STAFF REPORT

Case Number: 2023-CAP-826 / 2023-CVR-826
Address: 4195 Millersville Road (*Approximate Address*)
Location: Washington Township, Council District #9
Petitioner: Garvey Properties, LLC, by Joseph D. Calderon
Request: Modification of Development Statement and Site Plan related to 2013-ZON-037 to remove the requirement for landscaping and buffering along Millersville Road and Meadows Parkway, and to provide for storage buildings as shown on the site plan submitted with this petition.

Variance of Development Standards of the Consolidated Zoning and Subdivision Ordinance to provide for a building located ten feet from Meadows Parkway with zero transparency (40% transparency required for buildings within 50 feet of a local street).

DRAWING NUMBER
C101

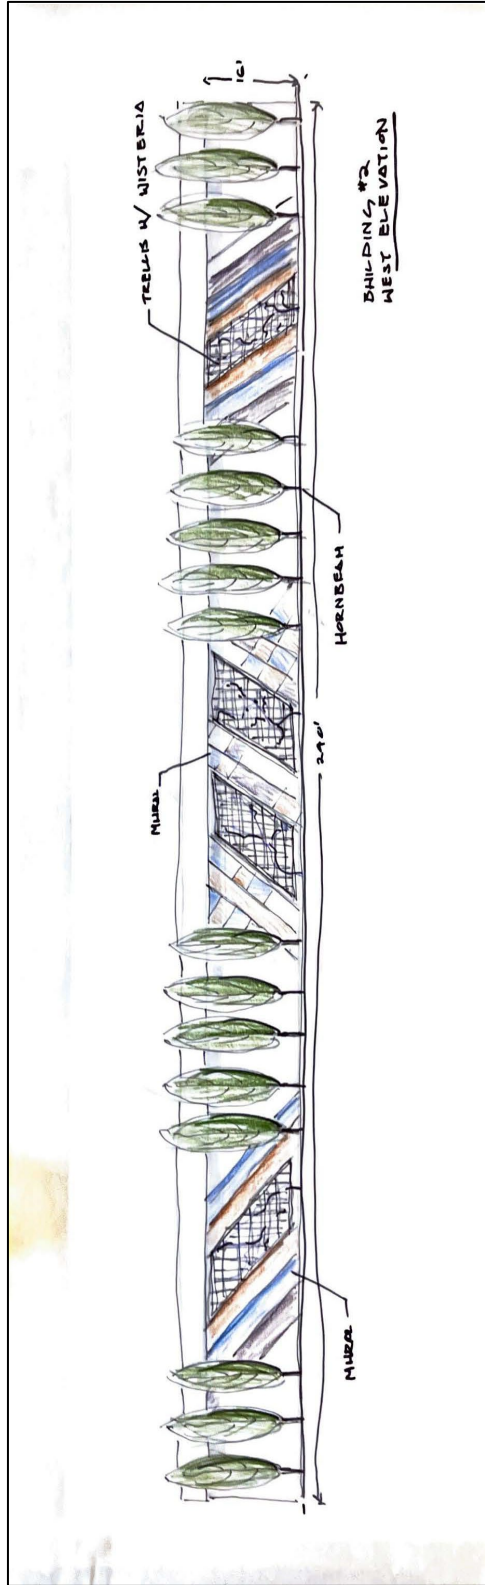
- ◇ As can be seen in one of the photographs below, much of the site is surrounded by a rusty chain-link fence with barbed wire wrapped in razor wire and grown up with weedy vegetation. According to the Ordinance, with the construction of the proposed buildings, much of this fence will have to be removed. However, portions of it along both frontages would be permitted to remain. This fence is not pedestrian-friendly. The barbed and razor wire should be removed and the weedy vegetation along both frontages should be replaced with heavy and appropriate landscaping.

- ◇ This petition would provide for contractor storage units in the area previously approved for the lawn/turf farm and nursery.
- ◇ Storage units are permitted by the previous petition as they were permitted in the I-2-S district. If storage units were not already permitted on this site, staff would be unlikely to recommend their approval now, given the Comprehensive Land Use Plan recommendation of Village Mixed-Use and the changed character of the area.

- ◇ The storage units would provide “partial screening of material and vehicle storage” on site, as well as screening “operations in the storage yard area” as sought after in the previous petition. The proposed buildings would be required to be landscaped to the standards of the Ordinance.

1. Prior to the issuance of any Improvement Location Permit for this site, all barbed wire and razor shall be removed from the perimeter fence.
2. A landscape plan shall be submitted for Administrator's Approval prior to the issuance of any Improvement Location Permit for this site. The landscaping shall be in excess of that required by the Ordinance in order to screen the view of the remaining existing fence and the material storage behind it.
3. Building elevations for the Meadows Parkway façade of the proposed building shall be submitted for Administrator's Approval prior to the issuance of any Improvement Location Permit for the building. The façade shall be in substantial compliance with the Building Façade Illustration submitted on May 30, 2023.
